Access Compliance Report Public Rights-of-Way (Curb Ramps)

Main Street: **BROWNING_AVE** Cross Street: **BURNT_MILL_RD** Location: **NW**

ADA ID: **RPAT211012105815** Ramp Type: **Type 4 - Parallel** Initial Pass/Fail: **Fail** Overall Compliance: **No** Severity Score: **2**

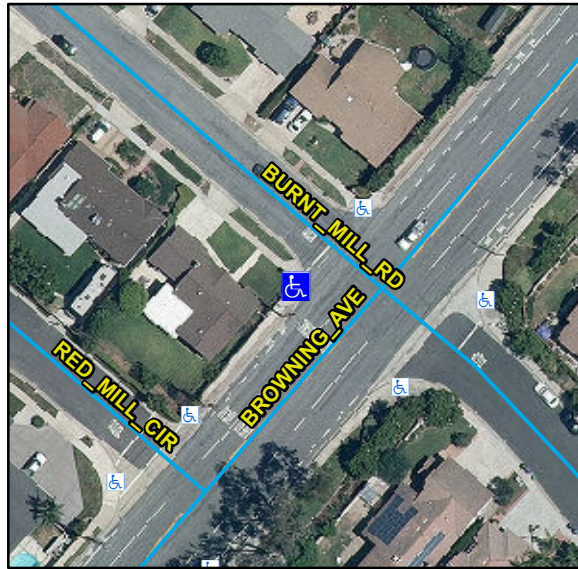
Compliance	Description	Data	Compliance	Description	Data
N/A	Ramp Length LT (in)	116	N/A	Ramp Length RT (in)	110
Yes	Ramp Width LT (in)	57	Yes	Ramp Width RT (in)	55
Yes	Ramp Run Slope LT (%)	4.9	Yes	Ramp Run Slope RT (%)	8.3
Yes	Ramp Cross Slope LT (%)	1.1	No	Ramp Cross Slope RT (%)	2.6
N/A	Landing Present	N/A	N/A	DWS Provided	N/A
N/A	Landing Length (in)	N/A	N/A	DWS Contrast	N/A
N/A	Landing Width (in)	N/A	N/A	DWS Length (in)	N/A
N/A	Landing Run Slope (%)	N/A	N/A	DWS Full Width	N/A
N/A	Landing Cross Slope (%)	N/A		DWS Offset Type	N/A
N/A	Landing Movement Obstructed?	N/A	N/A	DWS Offset Left (in)	N/A
	Landing Movement Type	N/A	N/A	DWS Offset Right (in)	N/A
N/A	Landing Shared	N/A			
N/A	Clear Space	Yes			
N/A	Clear Space To Crosswalk (in)	N/A			
N/A	Marked Crosswalk 1	No	N/A	Marked Crosswalk 2	No
	Crossing 1 Direction	S		Crossing 2 Direction	E
	Marked Crosswalk 1 Width (in)	N/A		Marked Crosswalk 2 Width (in)	N/A

Remove & Replace Curb Ramp With Two New Directional Ramps or Equivalent.

R304.5.3, STD 1115
